**Project BR 392(6)
S.R. 17 Bridge replacement over Bear Creek
Marion County**

**Project BR 392(6)
A Proposal to Replace the Bridge over Bear Creek on S.R. 17
Marion County**

Project BR 392(6)
S.R. 17 (U.S. 43) Bridge Replacement Over Bear Creek
Marion County, Alabama

ECOLOGICAL RESOURCES MAP

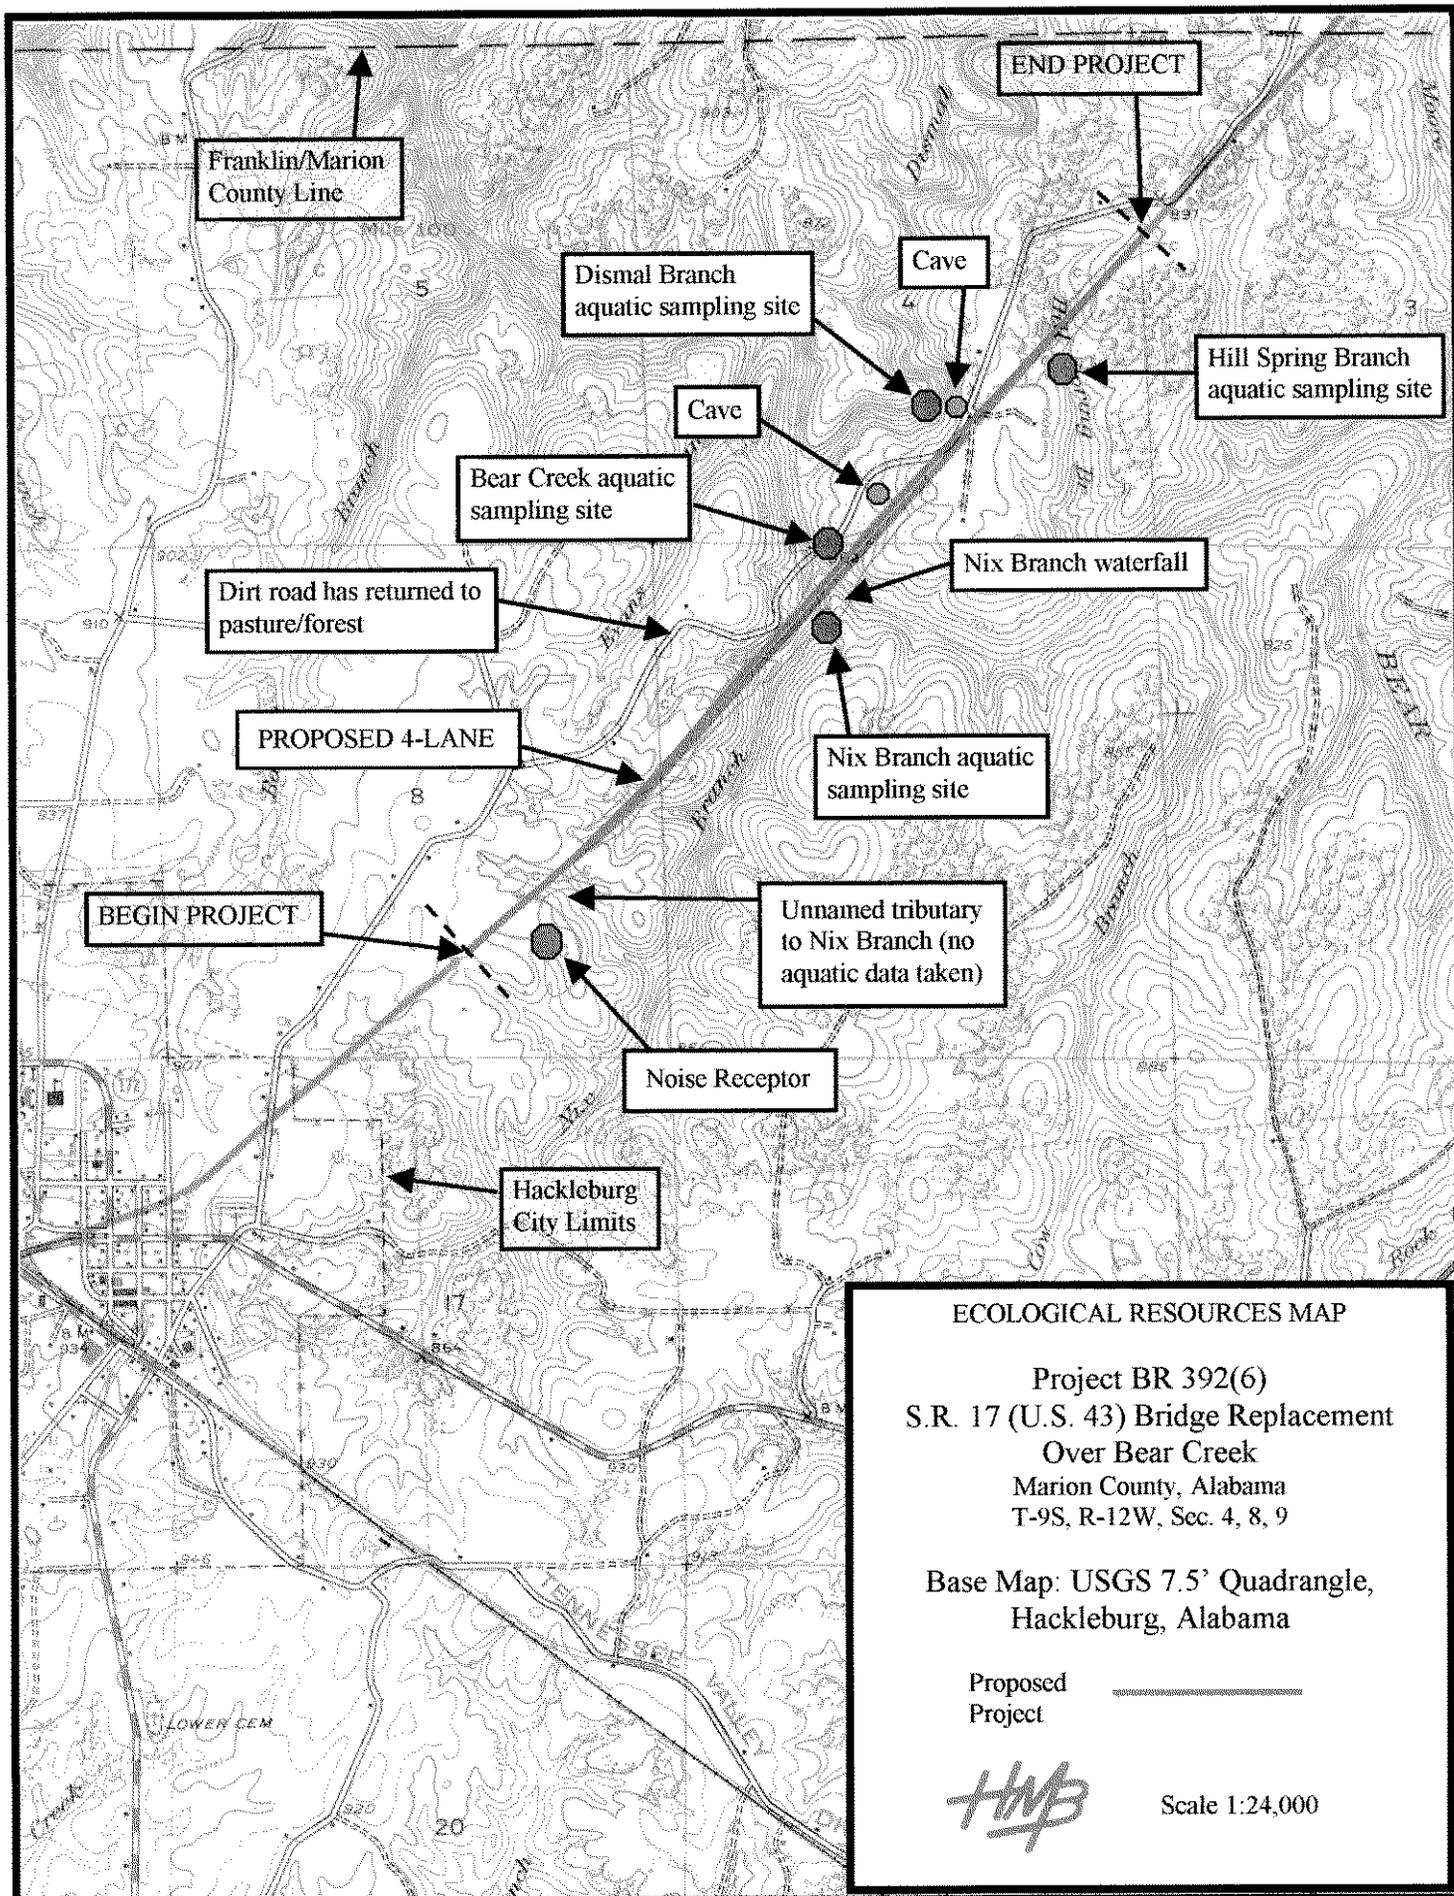
3) Concerning the presence of two caves on the project: The EA should determine if any karst protection measures are needed to avoid impacts to these geologic features.

- **Figure 2, Ecological Resources Map.** Two caves are shown on this map, and both are adjacent to the road construction area. The EA should determine if any specific karst protection measures are needed to avoid adverse impacts to these geologic features and water quality in the area.

Response: The two caves are within the construction limits of the project but the highway will not be constructed directly over either cave. Before initiation of construction, a soil profile will be made. If karst areas are detected they will be treated as lime sinks and sealed.
